CITY OF BELMONT

PLANNING & ZONING

Major Development Plan

Application number: MDP2022.02 – TKC Double Oak spec building

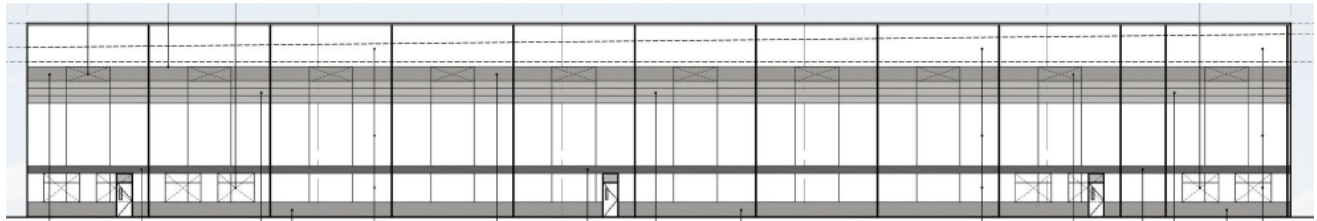
Architectural requirements for apartment buildings are in Section 4.6 (2) of the LDC. "Building walls visible from the public street shall be brick, cast concrete, stucco, stone, marble, decorative masonry unit, or other materials similar in appearance and durability." The building walls are proposed to be tilt-up concrete wall panels which is the most commonly used material used for

Staff has reviewed this schematic plan and finds it to be compliant with the requirements of the land development code (LDC). As stated before, this project is a “by-right” project, therefore, consistency findings are not required. Staff recommends approval of the schematic plan and forwarding this recommendation to city council.
